SOLICITATION AMENDMENT

Solicitation No: P14-0002
 Description: Westgreen Estates Unit 9
 Soundwall, Phase I
 Amendment No: One (1)
 Solicitation Due Date: December 4, 2013
 Solicitation Due Time: 2:00 p.m.

- Pre-bid sign-in sheet
- Geotechnical Report
- Pre-bid power point presentation
- Revised plan sheets attached 8 of 10 (revised joint detail), and 10 of 10 (revised pattern dimensions)
- Questions and Clarification

WALL DETAILS (1 OF 3) DWG NO. S-2.1 SHEET 8 OF 10

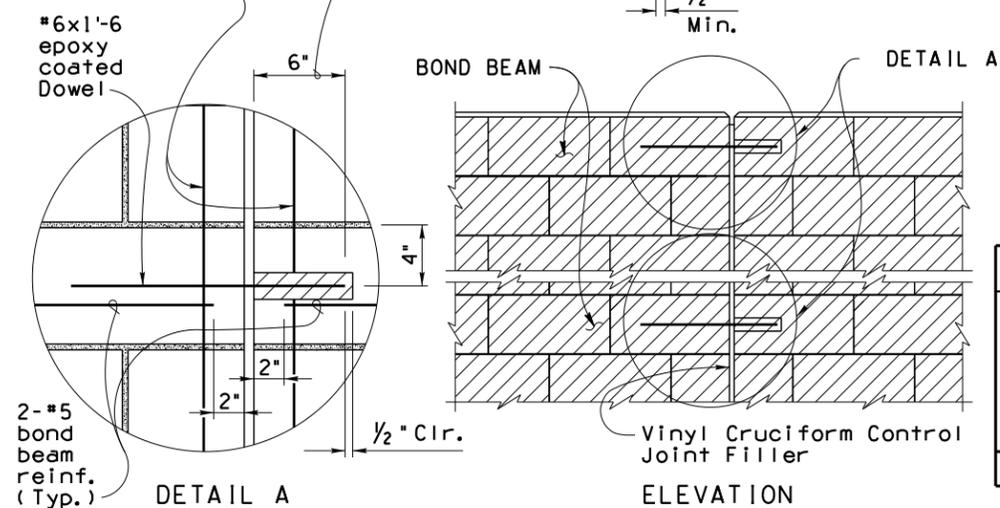
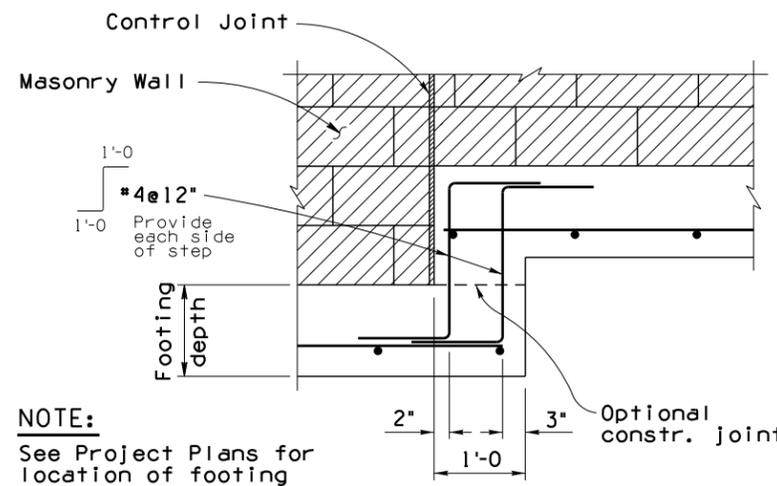
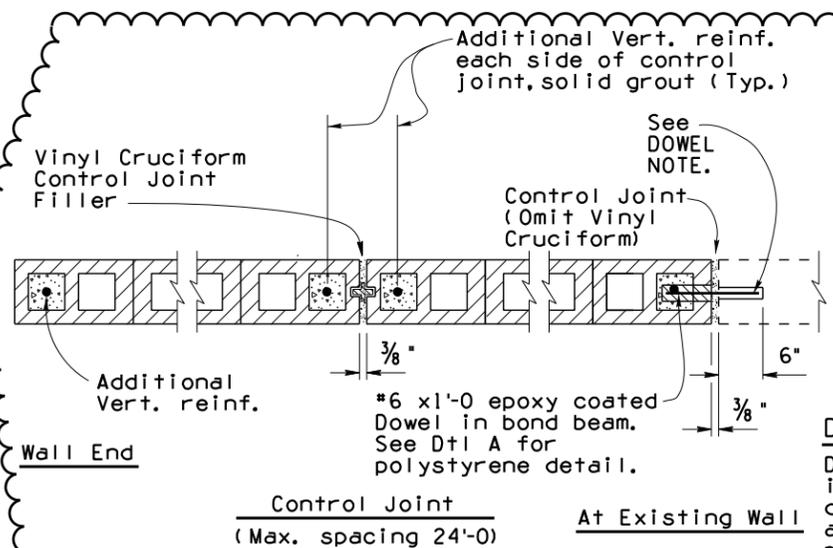
Revision:	Date:
⚠ Revised Joint Detail	11/22/13 - CRB

WALL DETAILS (3 OF 3) DWG NO. S-2.3 SHEET 10 OF 10

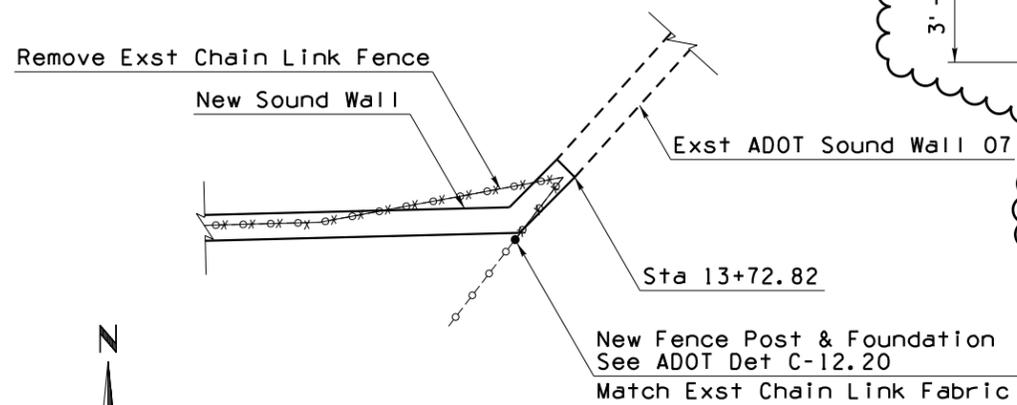
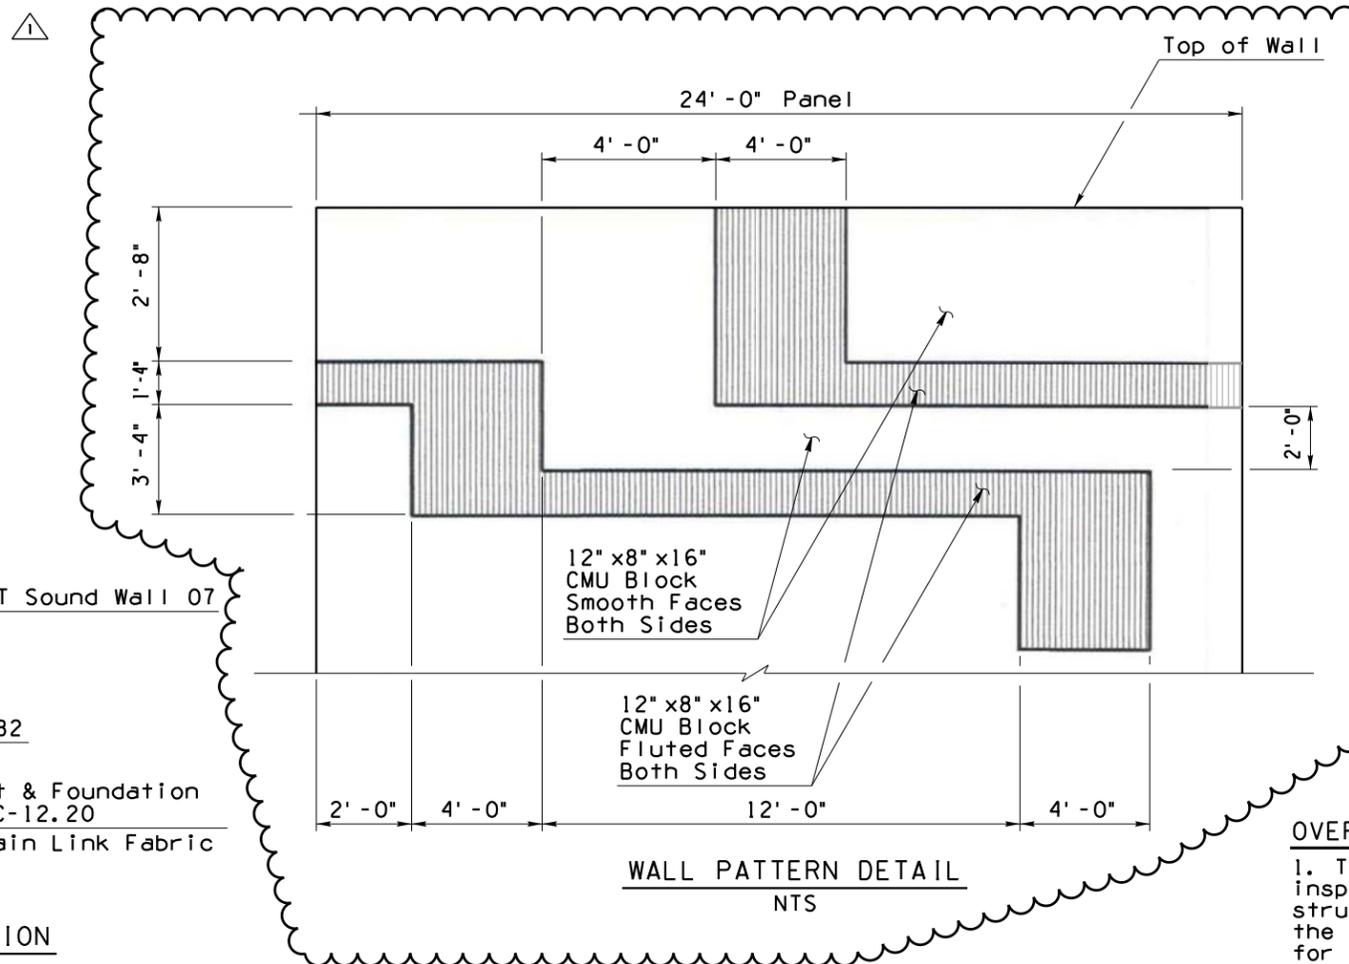
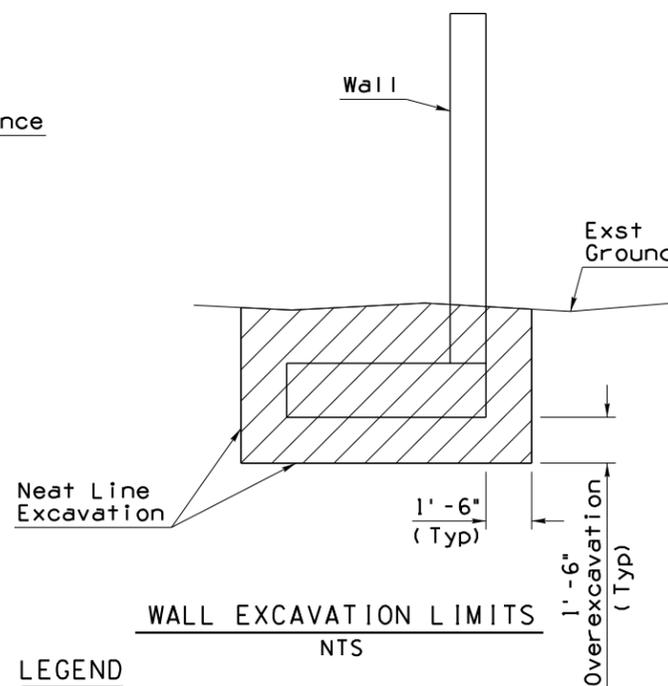
Revision:	Date:
△ Revise Pattern Dimensions	11/22/13 - CRB
